Amendments to the drawings**In the Drawings:**

REMARKS

FIG. 1
(Prior art)

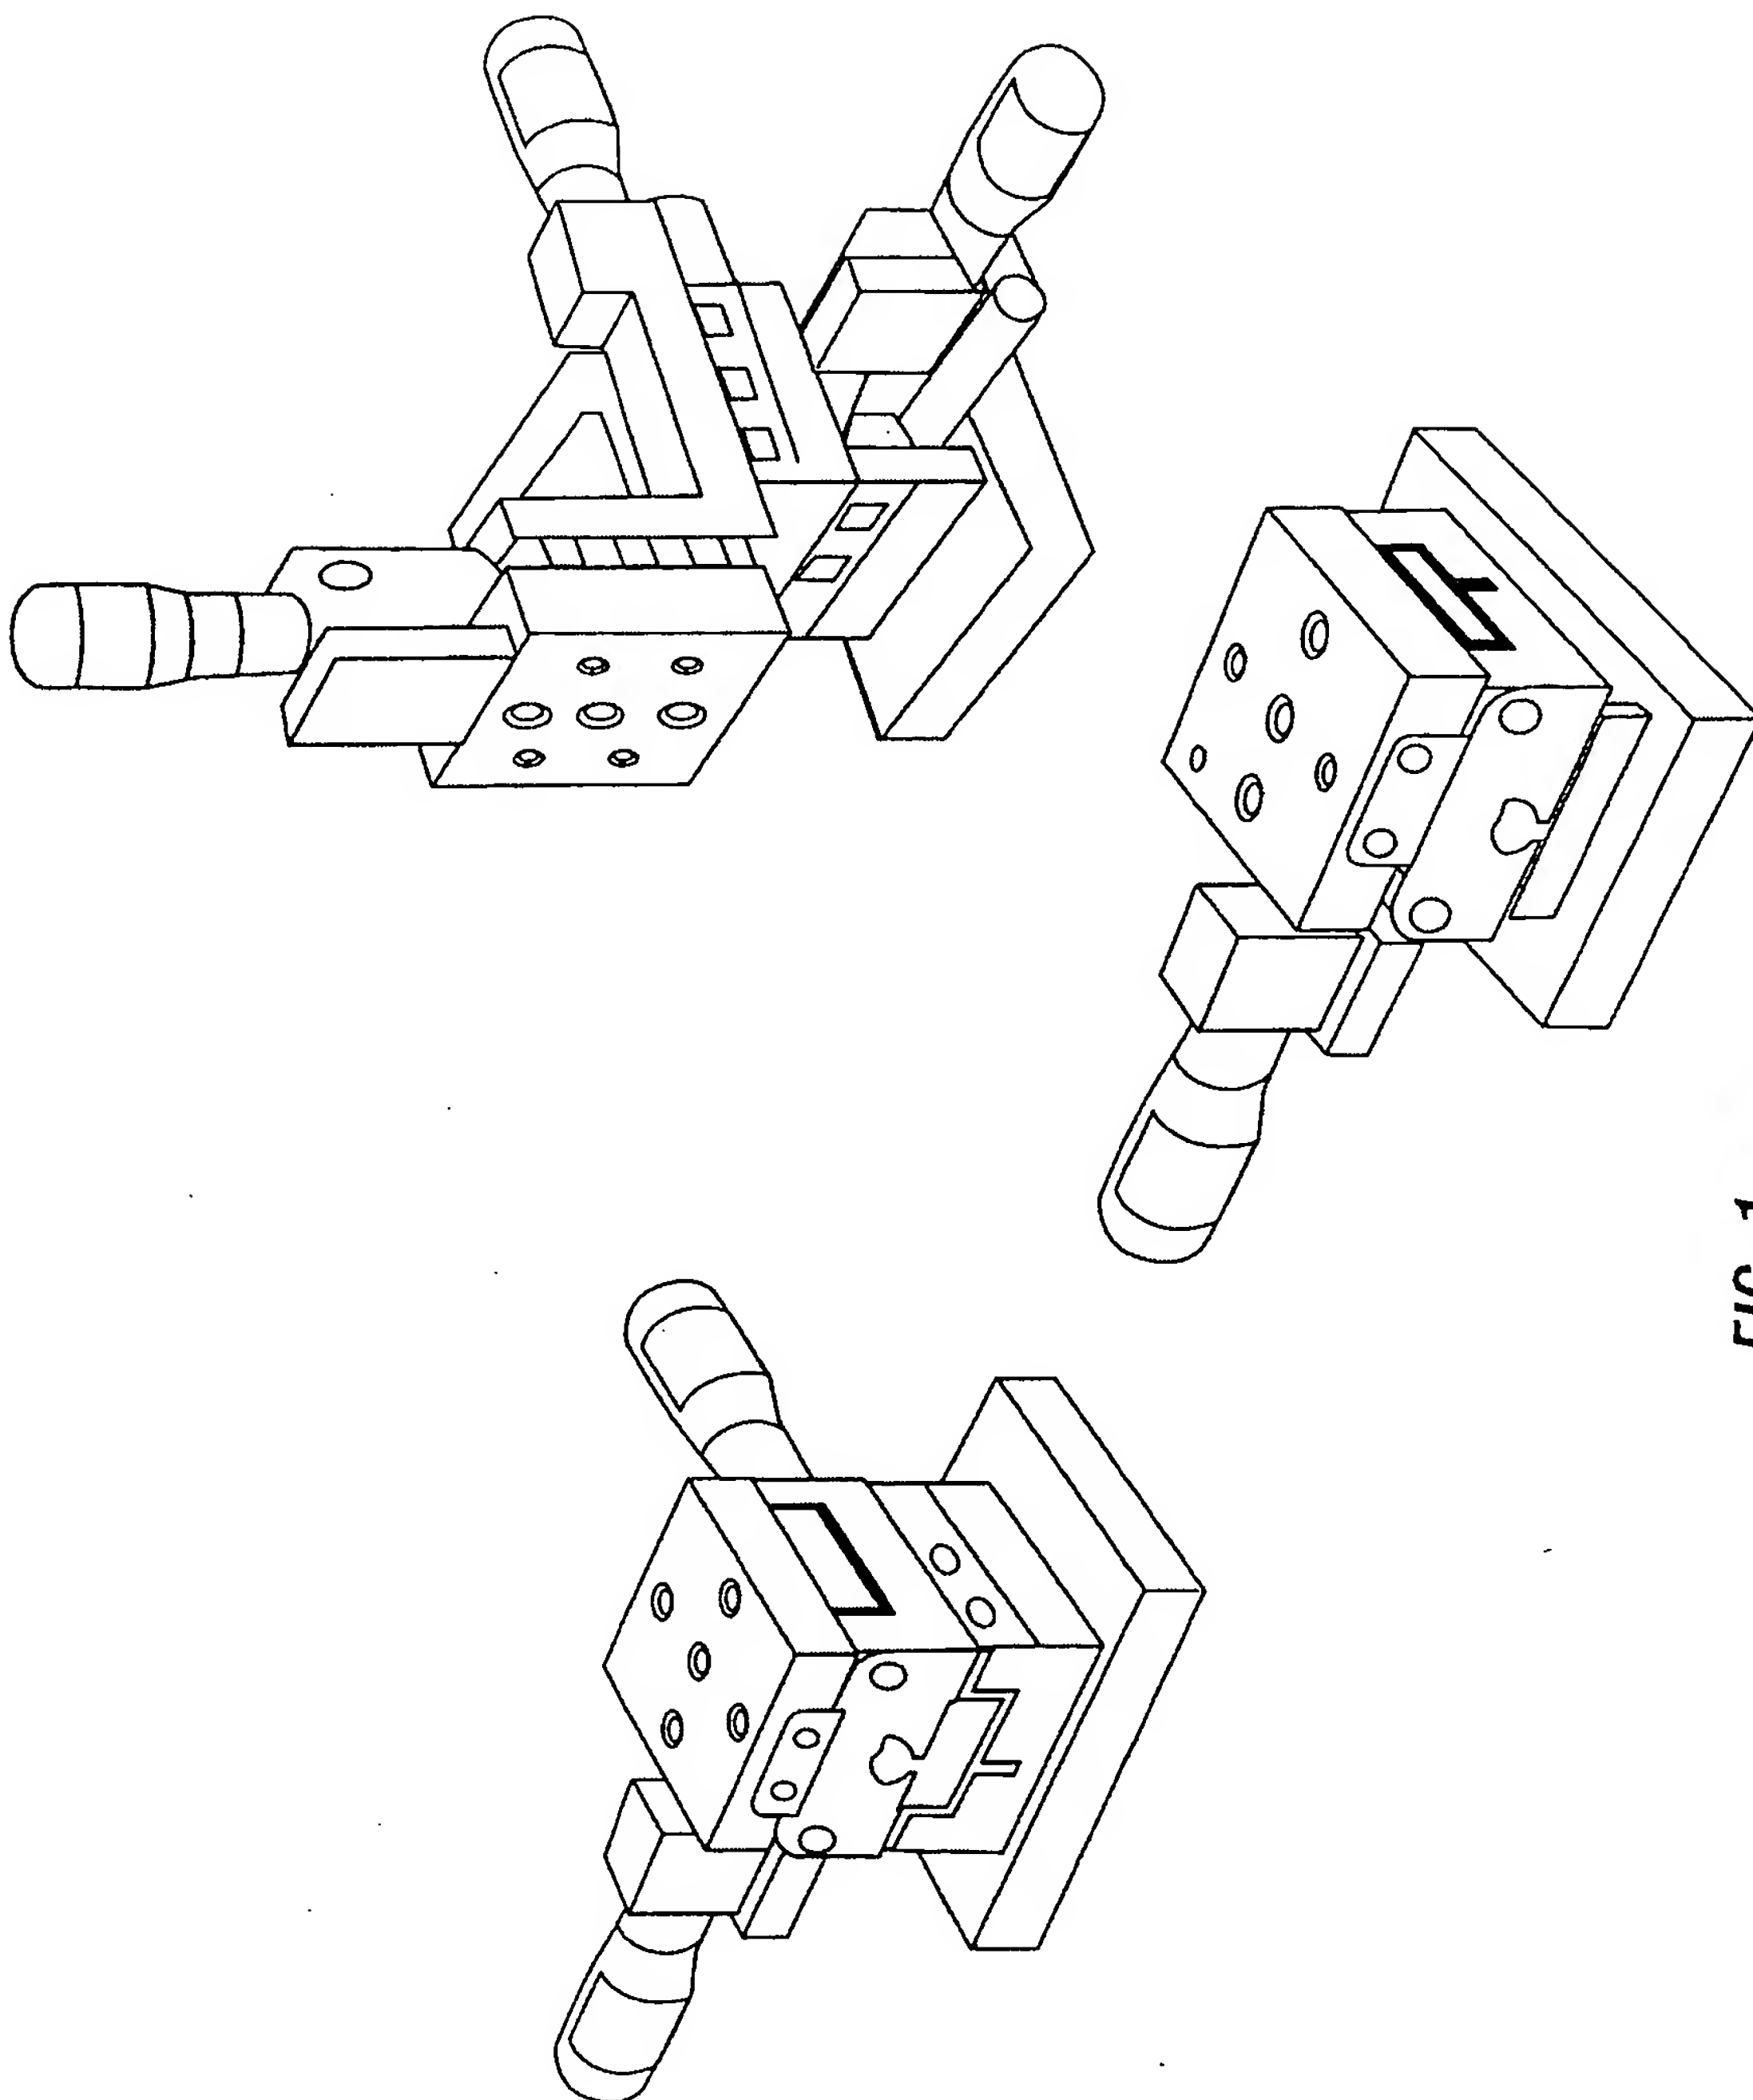
Proposed amendments to FIG. 1-4 and 7 are provided herewith. Enclosed are 5 sheets of mark-up copies and 5 sheets of clean as-amended copies, wherein FIG. 1-3 have the text “(Prior art)” added, FIG. 4 has the text “(Background art)” added, and FIG. 7 has the reference 20 replaced with the reference 68.

We respectfully ask entry of the proposed amended versions of FIG. 1-4 enclosed herewith. As filed, FIG. 1-3 inadvertently failed to include the text “(Prior art)” and FIG. 4 inadvertently failed to include the text “(Background art).” These amendments will bring the figures into conformity with the text in paragraphs [0014]-[0017] of the specification.

Added

FIG. 7
Rotary stage equipped with digital scale disk

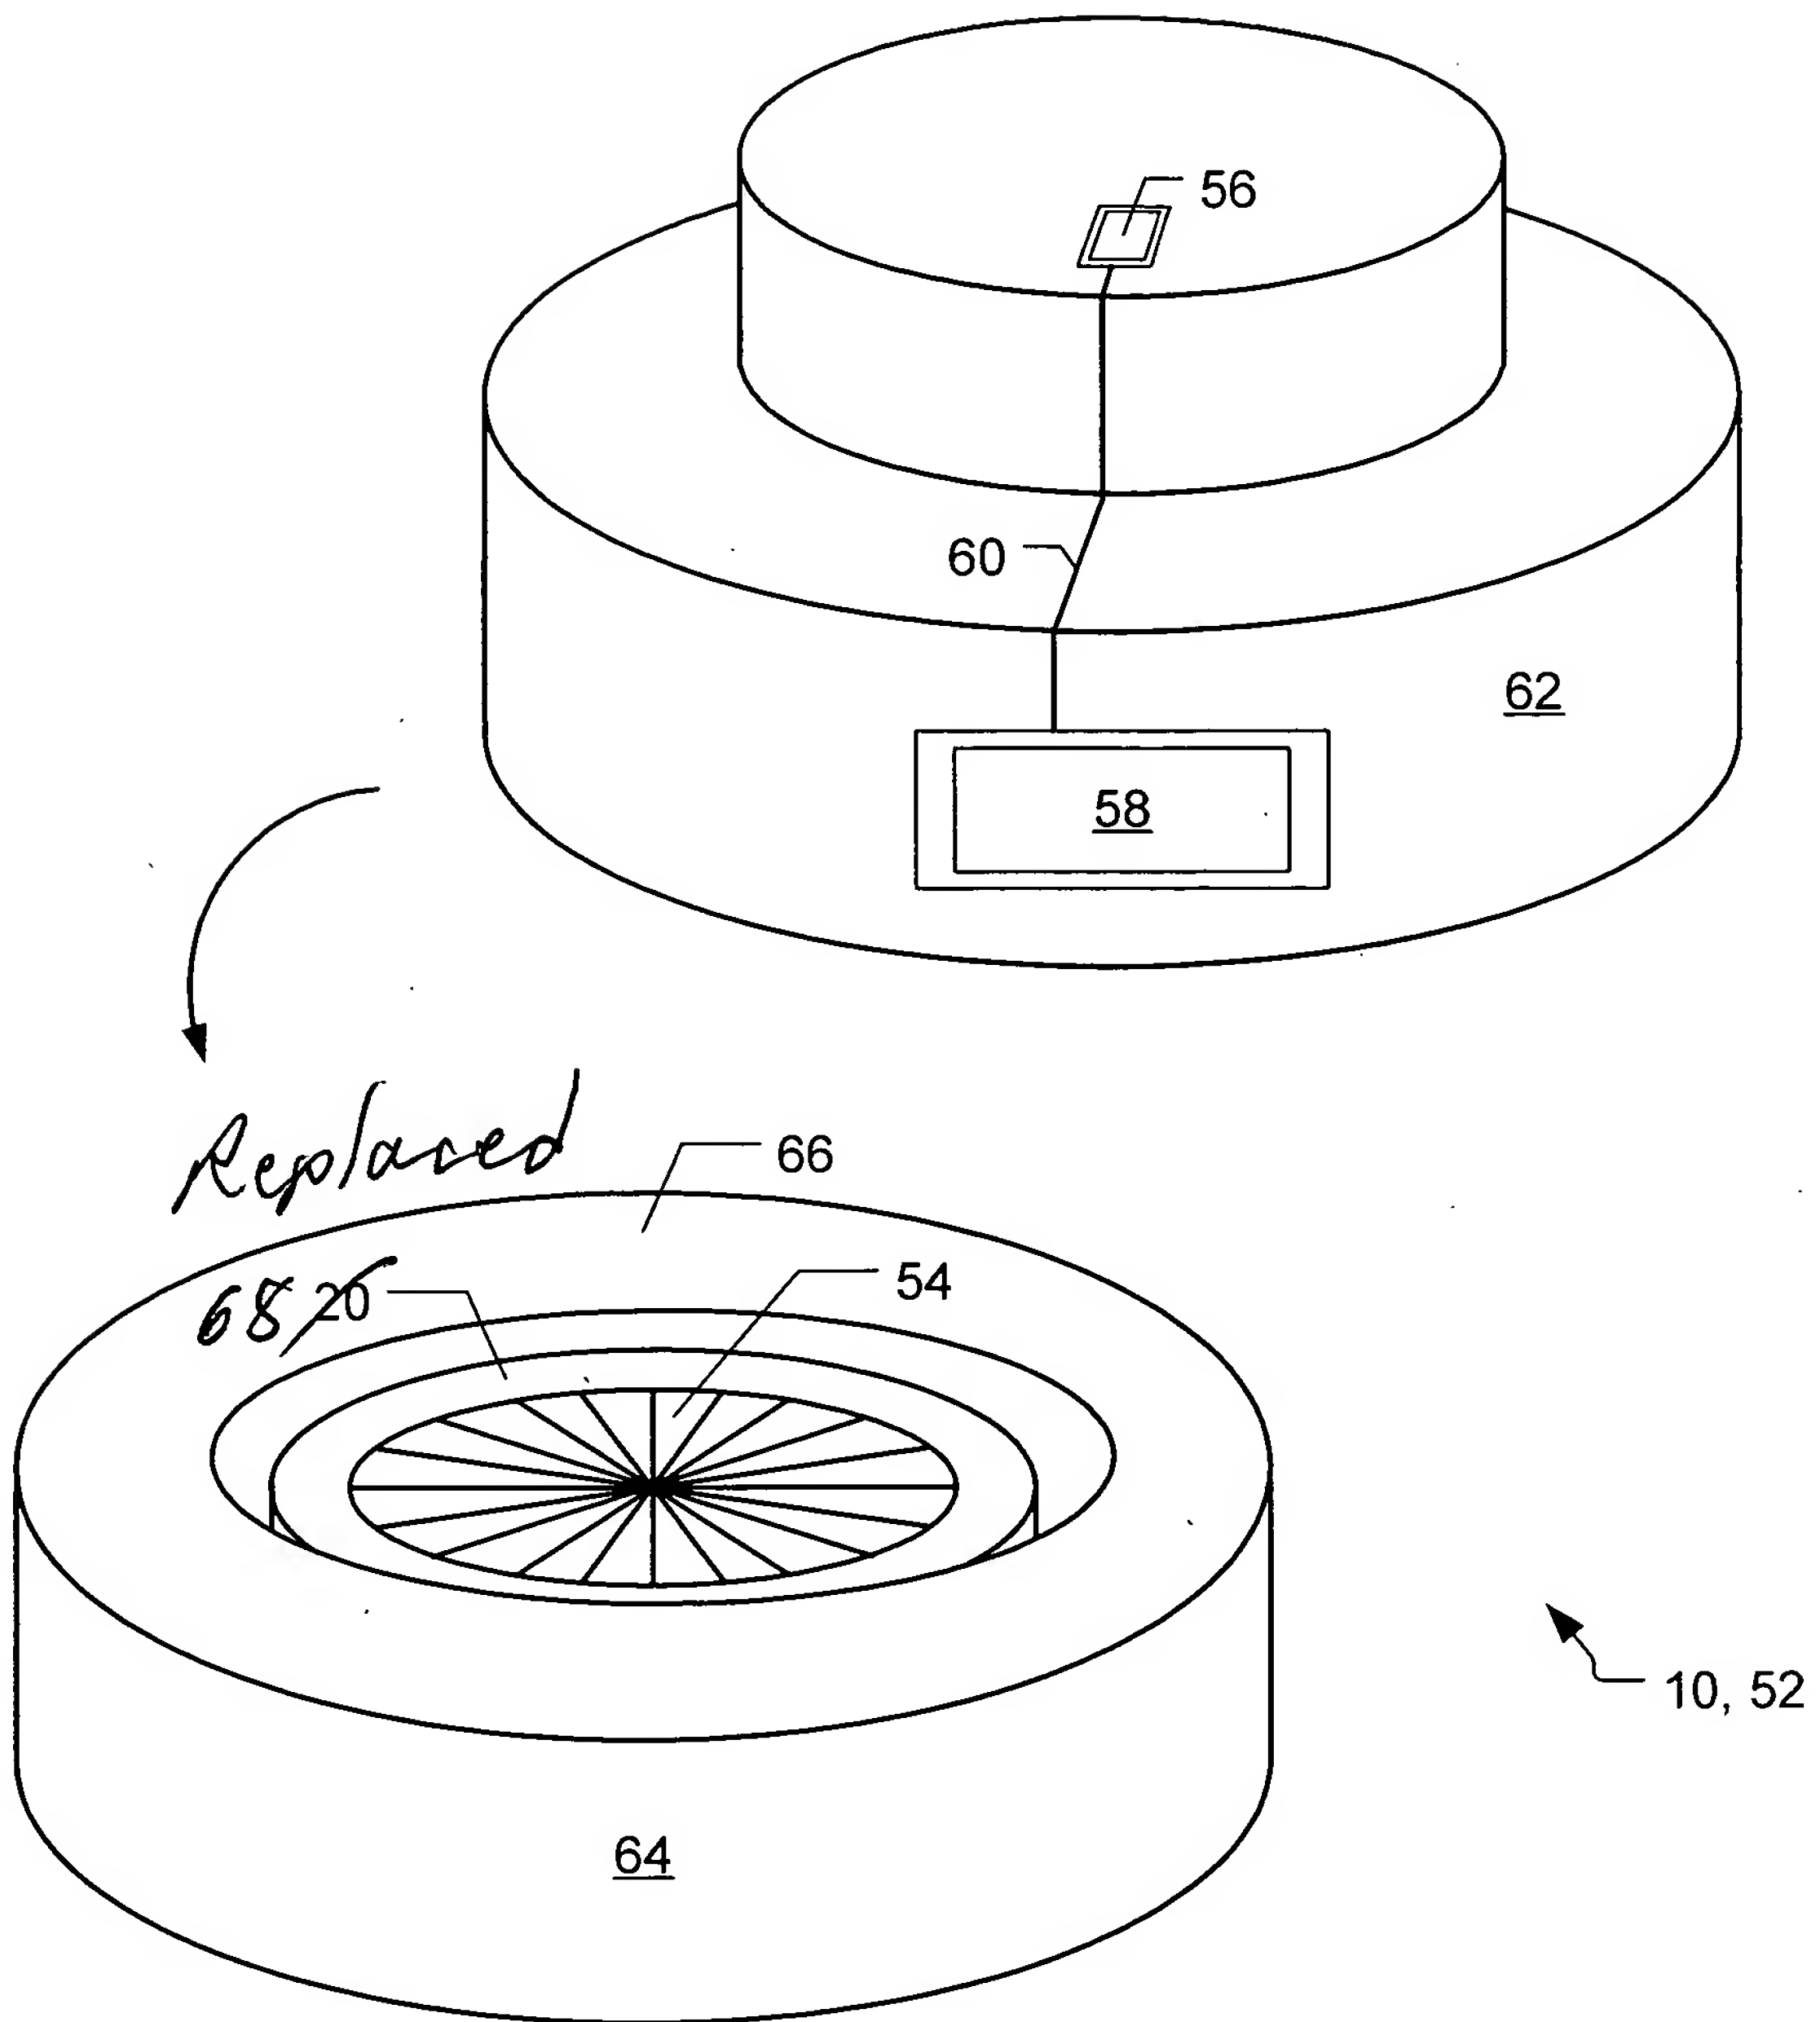
The Action here states, “*The drawings are objected to ... because they do not include the following reference sign(s) mentioned in the description: “68”*” This objection is well founded and corrective amendment is made herein.
